Name: Willow Ridge Subdivision – Preliminary Plan - NW Of 25 Road And Highway 340

TITLE HEADING: Preliminary Plan - Willow Ridge
Subdivision

The following is a response o the review Agency Comments concerning the Willow Ridge Preliminary Plan submittal, File #146-94.

PRELIMINARY STORMWATER MANAGEMENT PLAN	
& SHEET 2 REVISED	
PRELIMINARY PLAN	
Prepared by	Checked
Drawn by	Reviewed
Date	Scale
Sheet	of

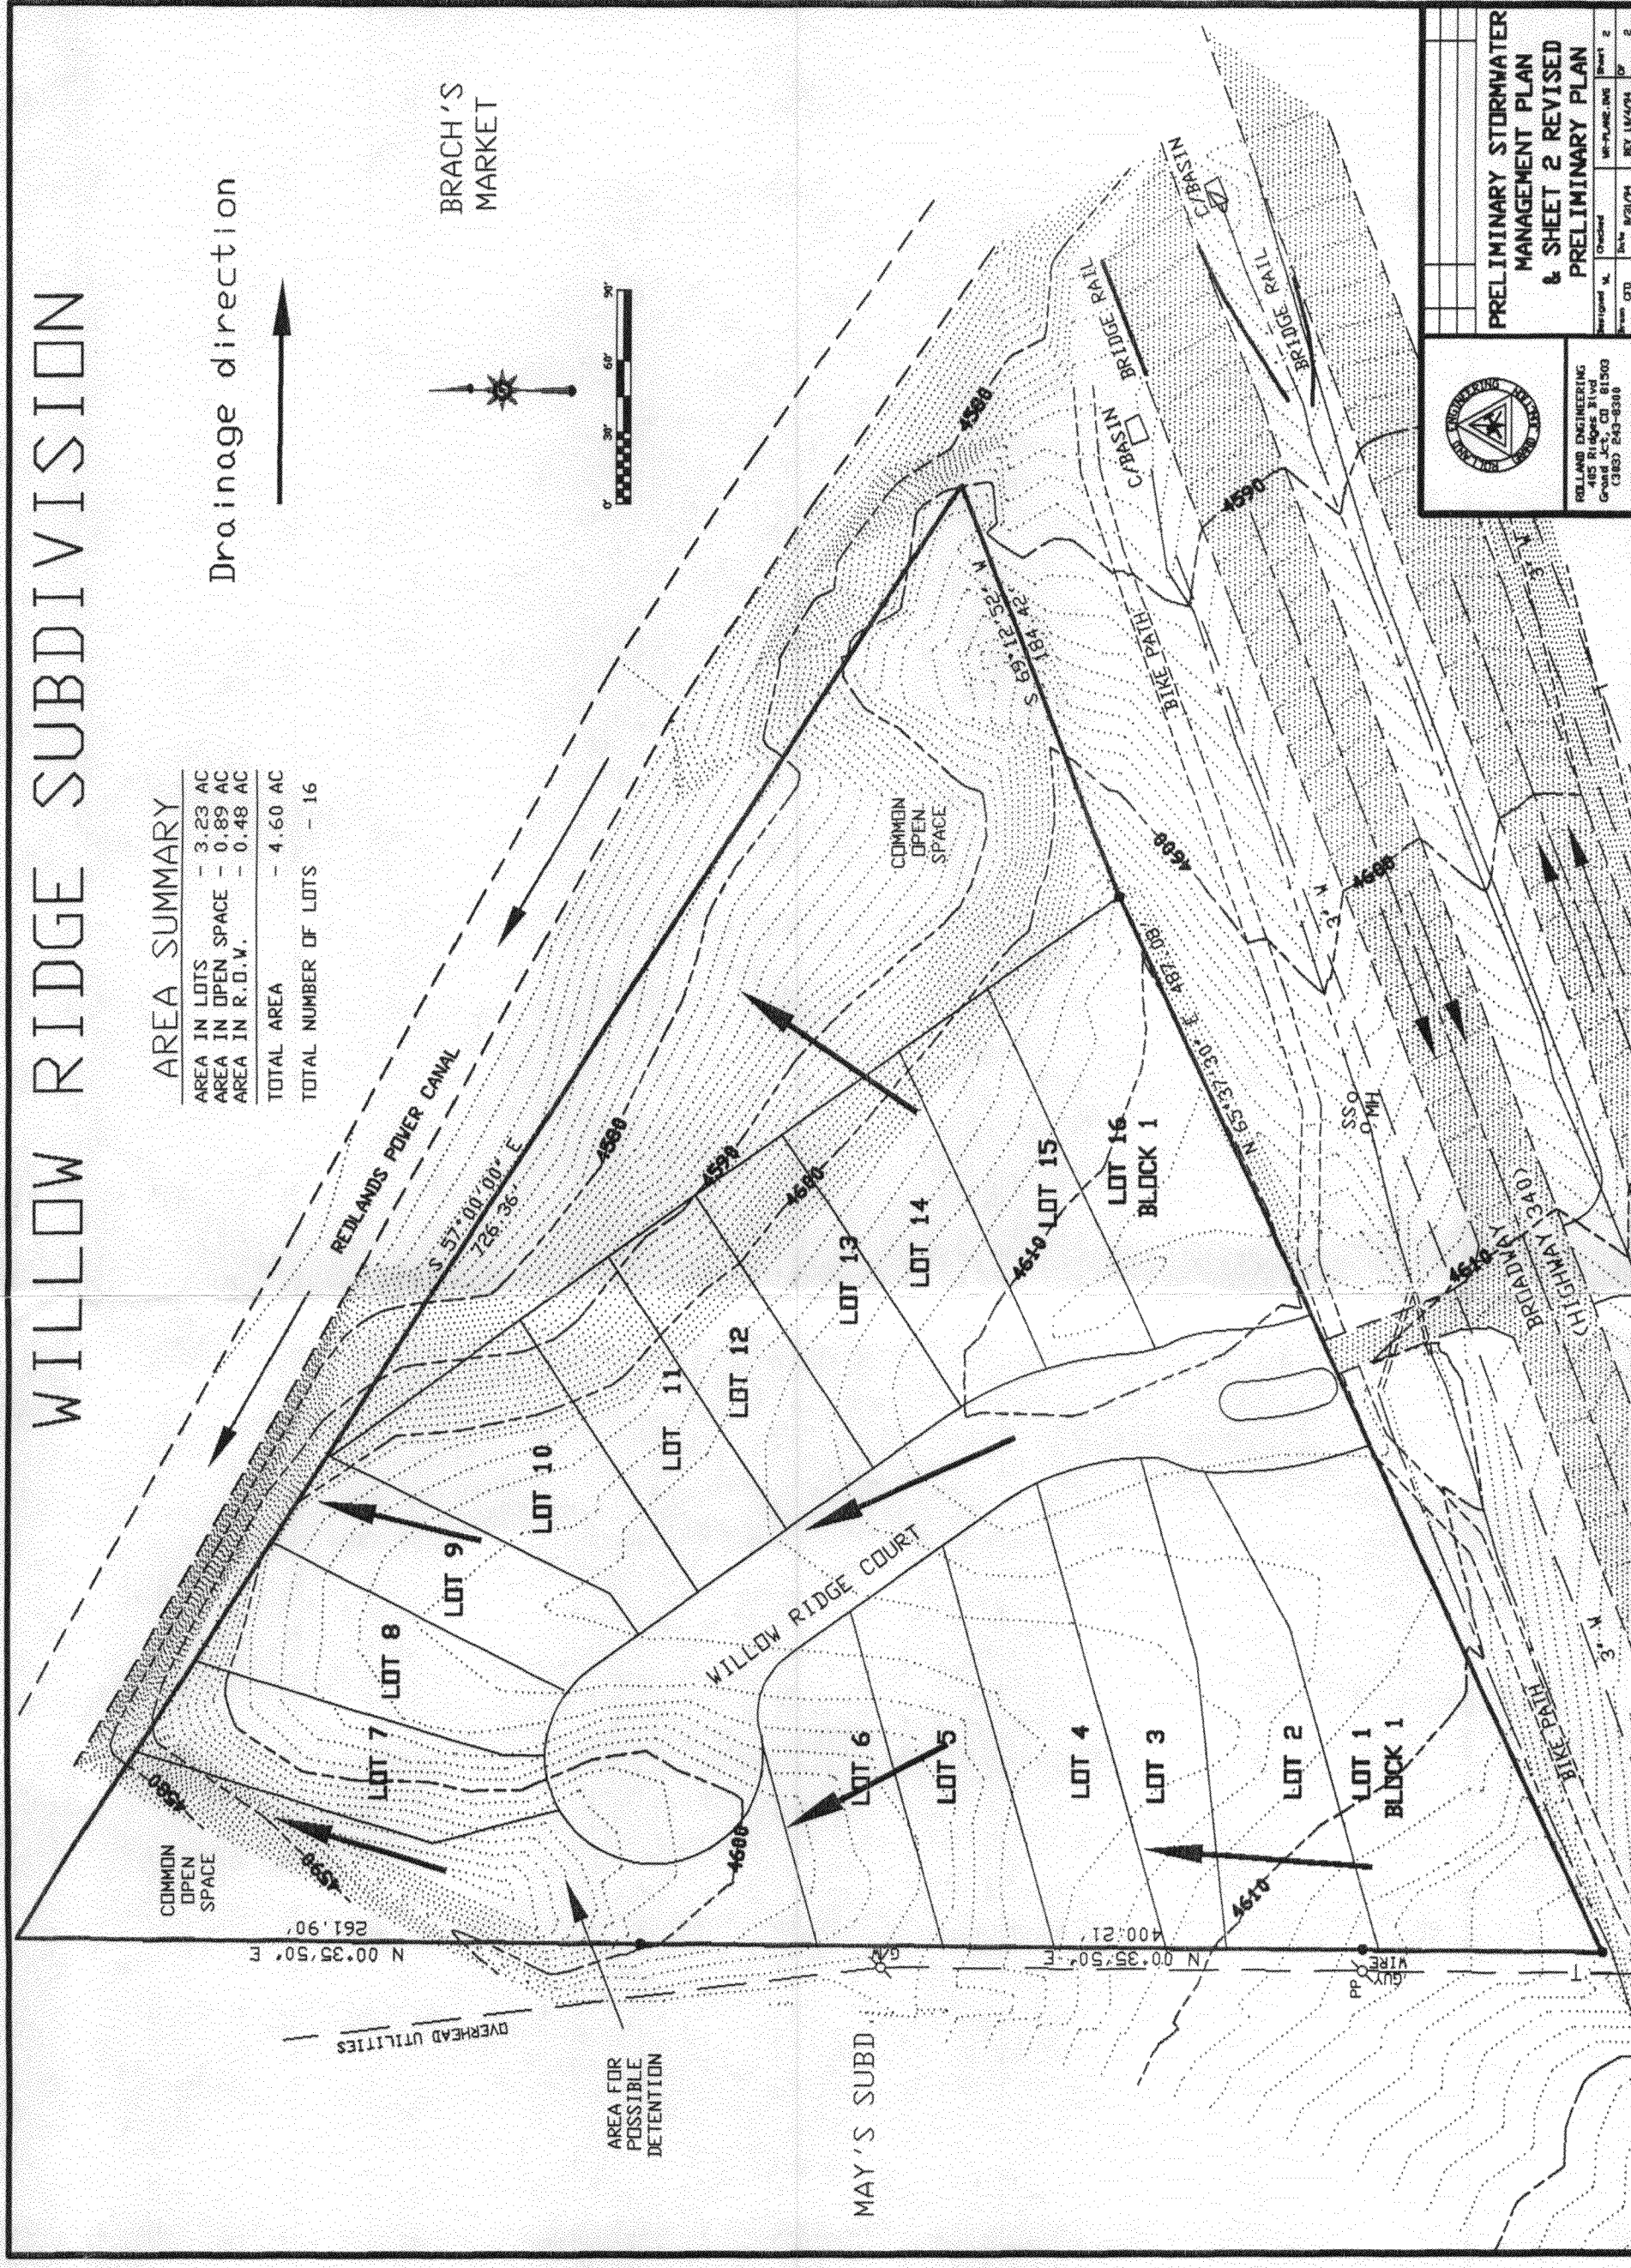
8) Drainage is a concern on the site. It appears from comments from the Redlands Water and Power Company that discharge will not be permitted into the canal as the petitioner has proposed. This issue should be determined and clarified with certainty before the petitioner proceeds with any proposal on the site.

REVISED PRELIMINARY
 PLAN - SHEET 1
 WILLOW RIDGE SUBD.

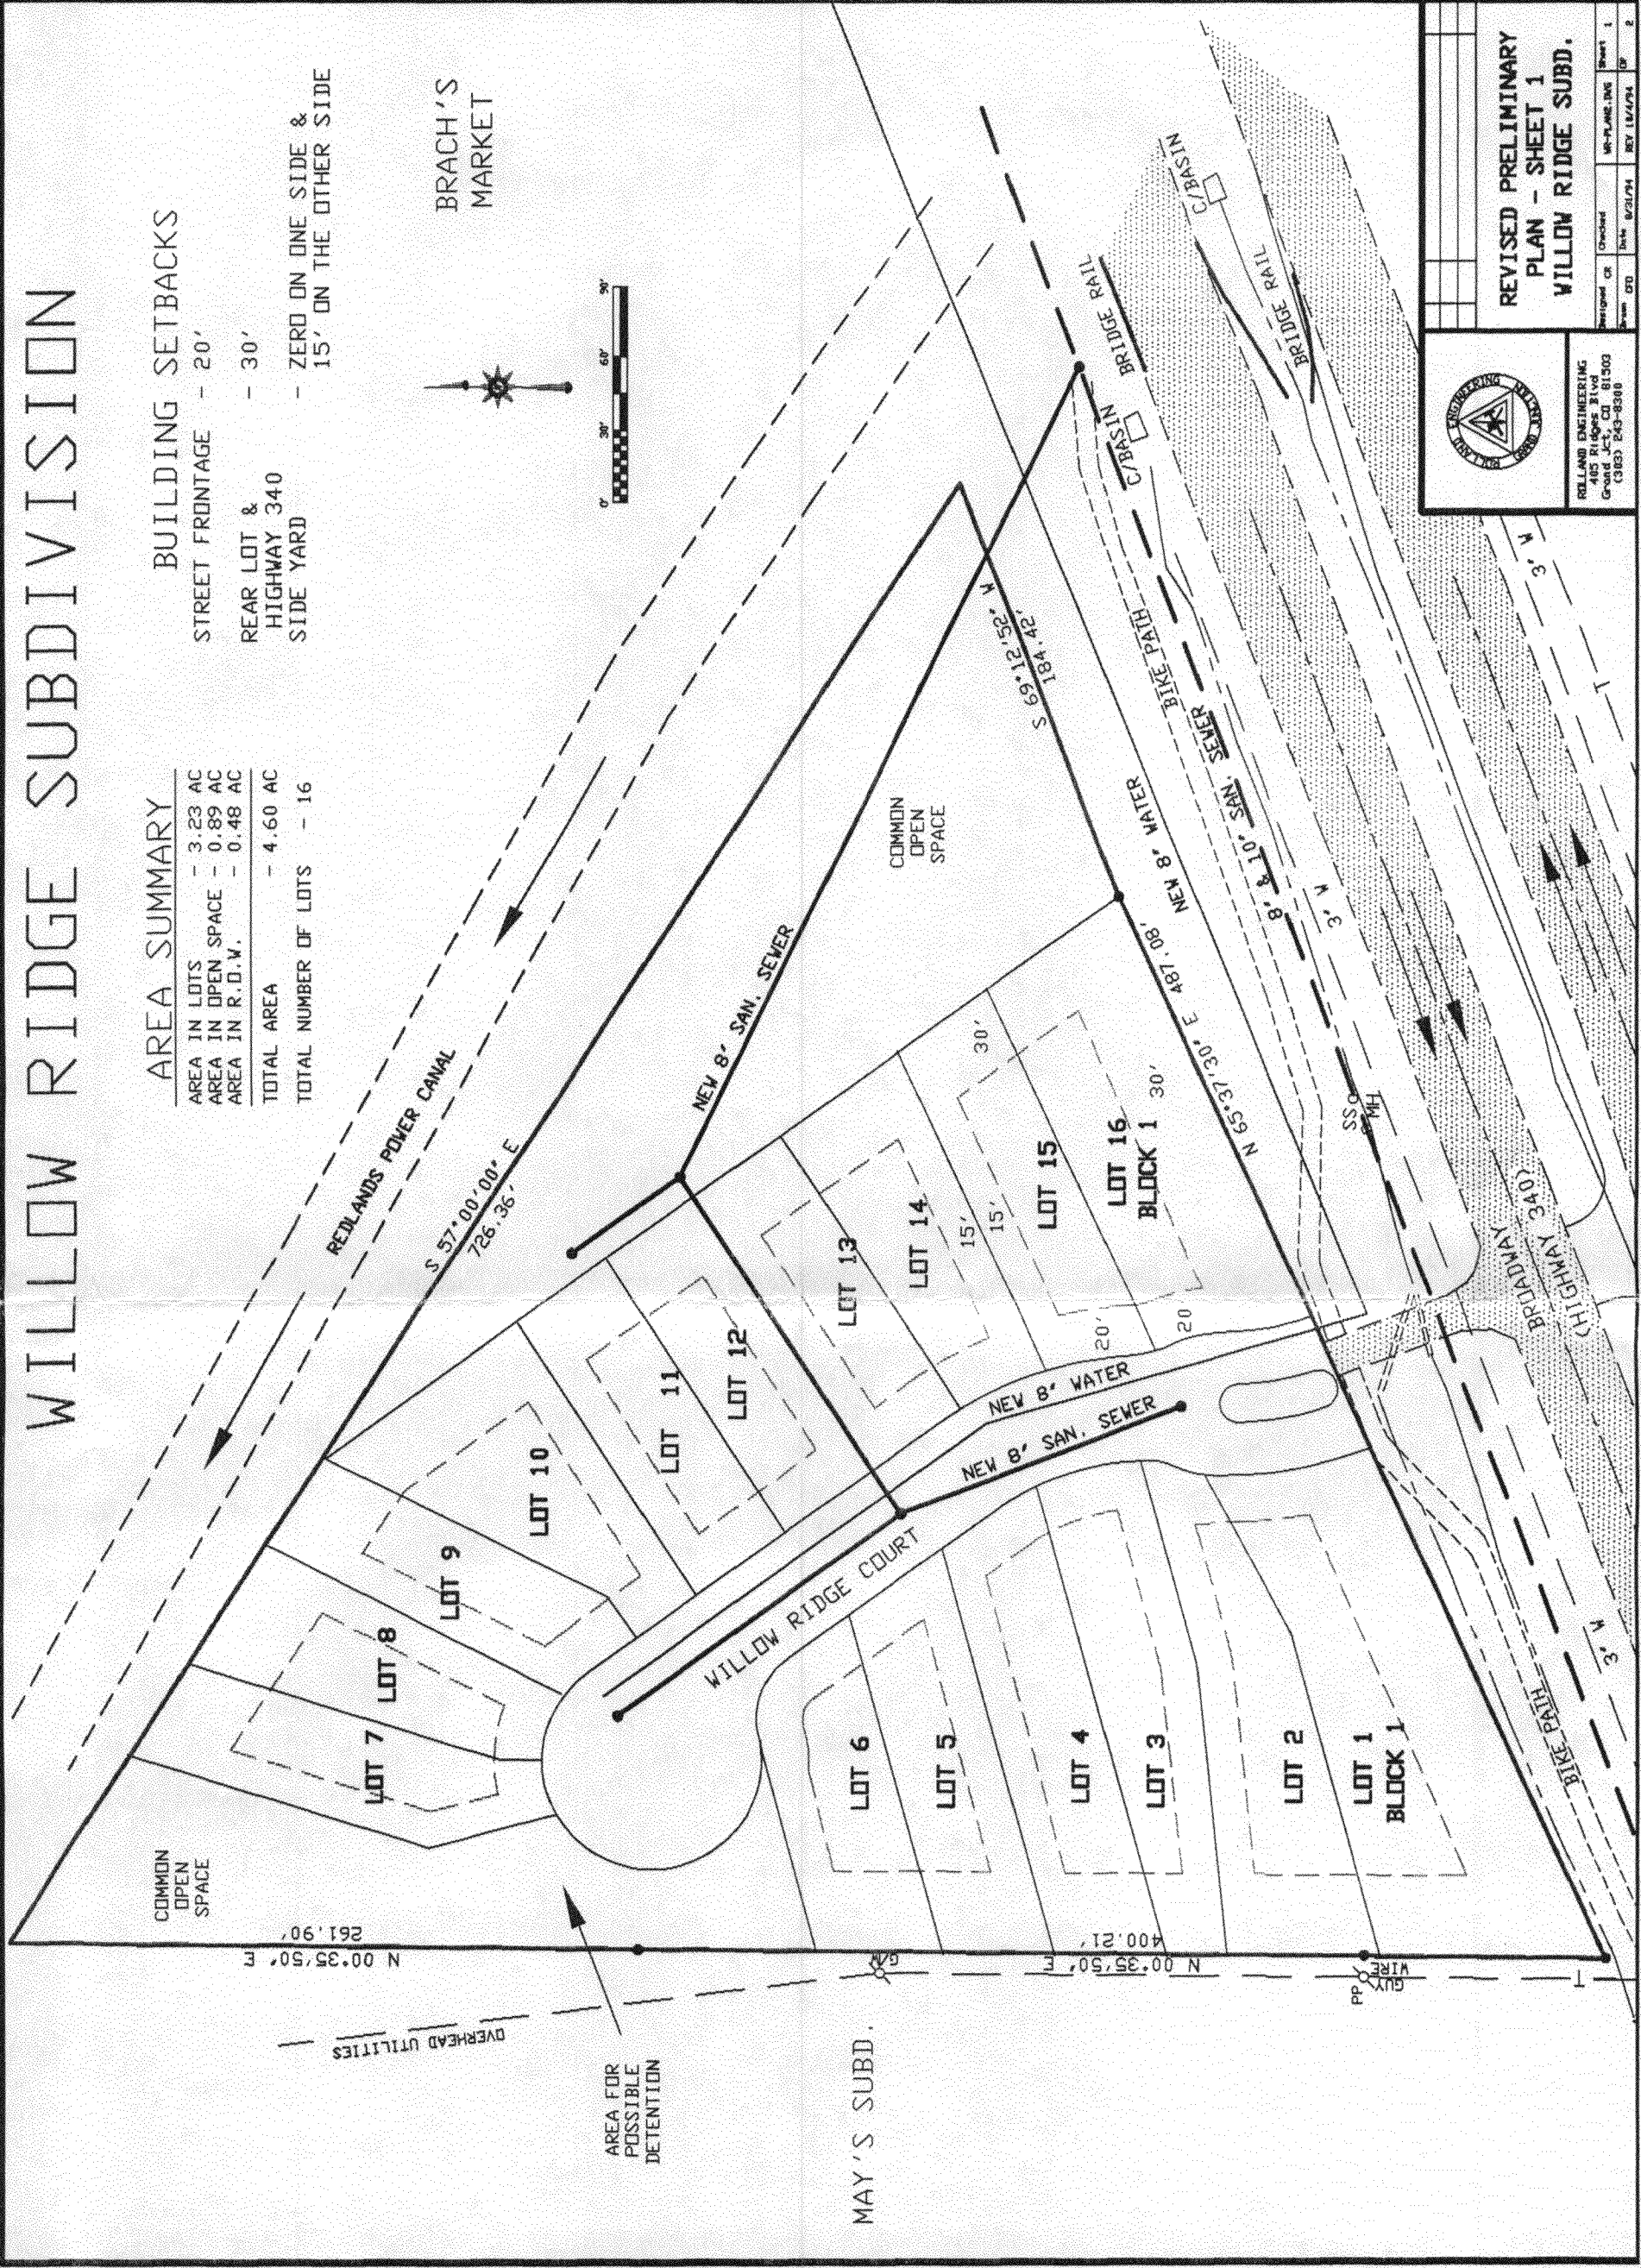
- 3) Several lots have street frontages of less than 20 feet which is the standard in the straight zones. In the Planned Residential zone, the petitioner is obligated to justify this substandard width. As proposed, the physical appearance of lots with these widths would create an ugly and wasteful appearance of a street frontage with solid driveways. The City will not accept such a development pattern.

6) The substandard cul-de-sac does not meet City standards. The cul-de-sac is described as an "auto court". It isn't clear what an "auto court" is. However, it is clear that what is being proposed is a substandard cul-de-sac. The proposed street configuration for the Broadway Townhouses project was a looped road with a cul-de-sac terminus on its north end. This type of roadway may work for a subdivision but not if 19 lots are envisioned. The proposed "auto court" clearly does not meet established City standards for street widths and turn-around radii. Problems with this width are restricted access by service vehicles (trash collection, delivery trucks, moving vans, emergency vehicles, etc.), maintenance of the road as a private street, and driveway locations, particularly with proposed Lot 15.

7) The severe slopes on the north and east portions of the property limit the carrying capacity of the site. The number of units that can reasonably fit on the property as individual lots is closer to 10 or 12. Evidence of over density are the odd lot configurations, narrow street frontages, need for zero side yard setbacks and the inclusion of a substandard private street section. Safety of residents on proposed Lots 9 through 12, especially for children, is a concern because of the precipitous drop from the cliff to the Redlands Canal.

3. Street frontage of 20' can be achieved in the final plan.
4. Zero lot line development avoids the 5' side yard setback (part of the bulk requirements for RSF-5, RSF-8) and allows its use as a 10' usable area for the homeowner. Maintenance easements can allow the adjacent property to be maintained and will be designated on the final plan. Neighbors now address this issue with building and maintaining fences without the designated easement in neighborhoods throughout the valley.

6. Limits to the carrying capacity of the site are only limited by the imagination of the developer. Units proposed for this site use the elevation change to provide multiple deck levels, walkout levels, and multi-story walkouts. Creatively developed units add interest, variety and unique living environments.
